VENDOR SERVICE PUBLICATION

SUBJECT: Teledyne Continental Motors Service Bulletins M85-14
and M85-16

SUBJECT: MAGNETO PRESSURIZATION FILTER

SUBJECT: Condenser P-Lead Torque Limit

FIGURE 1. MAGNETO PRESSURIZATION FILTER

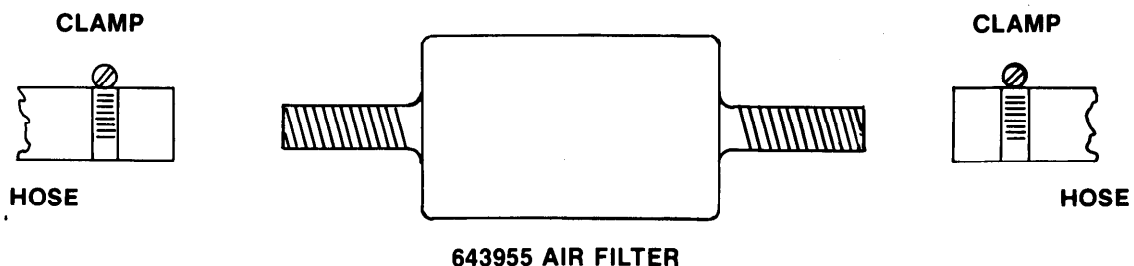
To prevent pressurization hoses from disengaging from the magneto air filter, P/N 643955, at altitude, it is recommended that at the next scheduled maintenance the following modification be performed, if not already accomplished.

Loosen both clamps as illustrated in Figure 1. Slide pressurization hoses from air filter. Holding body of filter in hand, roughen both ends of the filter with #280 grit (or equivalent) sandpaper in a clockwise direction. Wipe sanded areas clean of abrasives prior to reinstalling hoses and securing clamp. Make Log Book entry reflecting compliance.
